Product Change Notification

NOTIFICATION NO.	ISSUE DATE	LAST BUY DATE	LAST SHIP DATE
EU-PCN-20250701-01 Rev.1	17.02.2026	---	---

Rev. 1: Reflective~~-and transmissive~~ photointerrupters, please see the attached list of affected models. **This PCN is withdrawn for models GP1S173LCS2F and GP1A173LCS5F.**

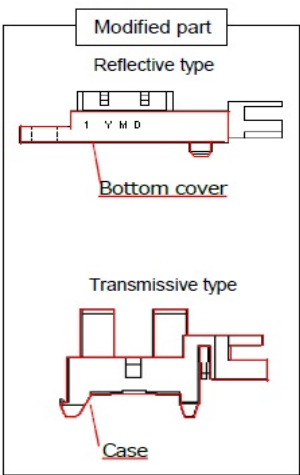
Due to our efforts to address environmentally hazardous substances, we will be changing the resin used for the cases and bottom covers of certain photointerrupters from PFAS-containing to PFAS-free.

Reflective type models :
The resin for the bottom cover will be changed.
Transmissive type models:
The resin for the entire case will be changed.

Rev.1: Background of the Withdrawal
While preparing for the transition, we re-evaluated the product's applications. As a result, we identified significant concerns in the change of the UL94 flammability rating (V-0 to V-2). Following a careful internal review, we have decided to cancel the transition to this resin and withdraw our previous notification regarding this change for the a/m models.
We will continue our efforts to select and verify alternative resins that maintain the current flammability rating and will provide further updates as soon as a viable solution is established.
